AMENDMENT OF SOLICITATION/MODIFICATION OF CONTRACT		BPA NO.	1. CONTRACT ID CODE	PAGE 1	OF PAGES 28
2. AMENDMENT/MODIFICATION NO. A00005		3. EFFECTIVE DATE 04-16-2015	4. REQUISITION/PURCHASE REQ. NO. 675-15-2-3245-0009		5. PROJECT NO.(If applicable) 675-13-151
6. ISSUED BY Department of Veterans Affairs Orlando VA Medical Center 5201 Raymond Street Orlando FL 32803		CODE	7. ADMINISTERED BY (If other than Item 6) Department of Veterans Affairs Network Contracting Activity 8 (NCO 8) Orlando VA Medical Center 5201 Raymond Street Orlando FL 32803		CODE 00675
8. NAME AND ADDRESS OF CONTRACTOR (No., street, county, State and ZIP Code) To all Offerors/Bidders			(X)	9A. AMENDMENT OF SOLICITATION NO. VA248-15-R-0752	
			X	9B. DATED (SEE ITEM 11)	
				10A. MODIFICATION OF CONTRACT/ORDER NO.	
				10B. DATED (SEE ITEM 13)	
CODE		FACILITY CODE

1. The record of Request for Information (RFI) submitted to date and the remaining Government responses all of which can be found in the attached RFI Tracking Log.
2. A revised Price Offer Schedule Template
3. Drawings E404 and E405 and
4. Addendum #1, Demolition Plan

Request for Information (RFI) Tracking Log**Solicitation: VA-248-15-R-0752****Project:

TELEPHONE TRACE A201 - SPECIAL SYSTEMS
SCALE: 1/4" = 1'-0"

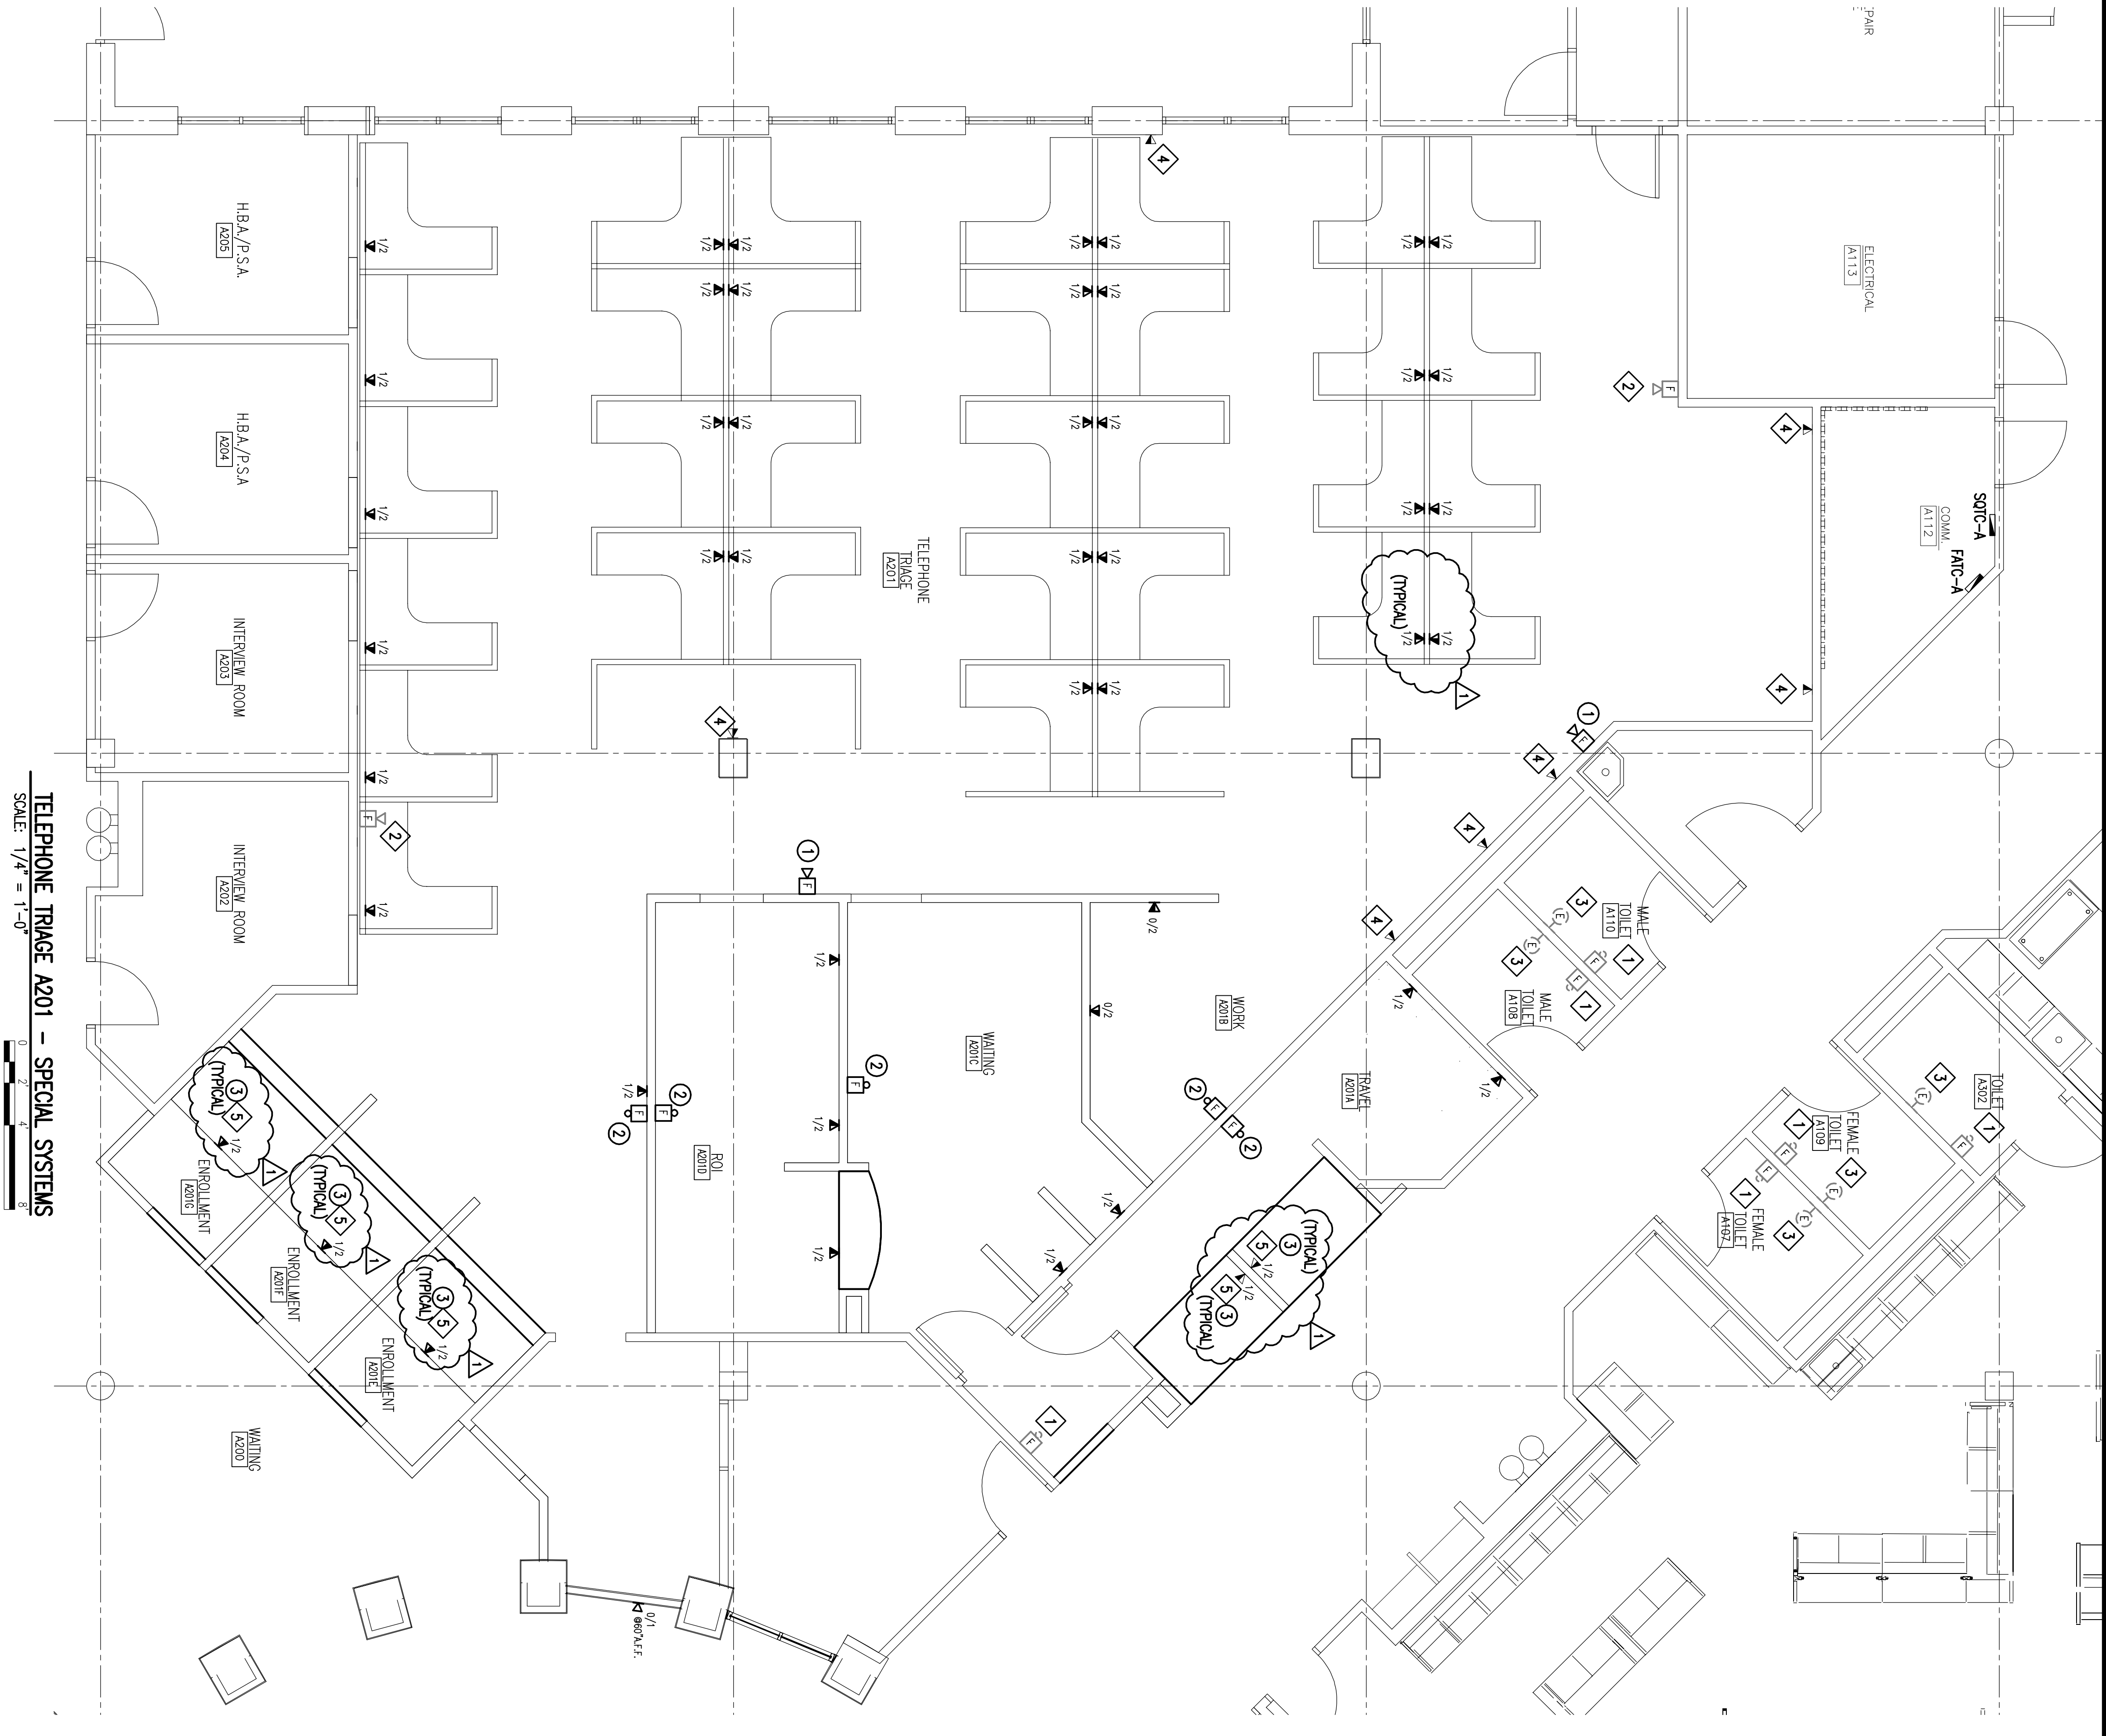
Response	VA standard. Provide specified product.		
56.	(6) Drawing E405 shows 32 new telephone/data outlets at modular furniture work stations and 10 more new telephone/data outlets at new walls. The following questions result: a) Does every tele/data line homerun all the way back to a telephone room? b) Where is this telephone room located? c) The groups of modular furniture with 8 and 10 work stations will have 24 or 30 CAT 6 cables leaving that location to handle the requirement for 3 lines per jack. Will this bundle of cables get to above the ceiling through power poles at each end of the workstation group, or some other raceway accessed through the floor slab or nearby walls? Note: power is shown to work stations in power poles.	Blue Cord Design and Construction	04-03-2015

Response	See Restroom Phasing Plan for bidding purposes. Final Phasing Plan will depend on which restrooms are awarded.		
66.	(1) Drawing E405 shows 32 new telephone/data outlets at modular furniture work stations and 10 more new telephone/data outlets at new walls. The following questions result: a) Will there be adequate space for connection of the new tele/data lines to the existing equipment in the telephone room(s)? b) When can we be allowed in to see the tele/data room	Blue Cord Design and Construction	04-03-2015

Response	(a) Yes (b) A112 (c) Will be a combination of wall connections and utility poles. The detail will be coordinated with the furniture vendor after

award. Existing wiring may be reused if it is in good condition and if it is long enough otherwise new Cat 5E cables shall be installed. See RFI#66 for additional info. Also see revised sheets found in VA248-15-R-0752 Amendment A00005 as Attachment 3 Drawing E404-R1 and Attachment 4 Drawing E405-R1 each dated 4/13/15. Cat 5E Cabling is acceptable.

and existing equipment? c) Will the GC be responsible for providing any new tele/data equipment if needed to support all new lines?		
Response	<p>a) The GC will be required to install additional 48 port data patch panel and additional phone punch down block(s). Cat 5E cabling shall be used.</p> <p>b) See RFI Response #15.</p> <p>c) The GC will not be required to provide new switches, but will be responsible for providing, installing and testing all cabling.</p> <p>NOTE: a data/com outlet shall be installed in each Enrollment area A200A, A200B and A200C if the existing one data/com outlet is demolished.</p> <p>Also see revised sheets found in VA248-15-R-0752 Amendment A00005 as Attachment 3 Drawing E404-R1 and Attachment 4 Drawing E405-R1 each dated 4/13/15. Cat 5E Cabling is acceptable.</p>

Revisions	Date
1. REVERSE TELCOM OUTLETS AT ENROLLMENT AND TRAVEL DESK AND NOTES	4/13/2015
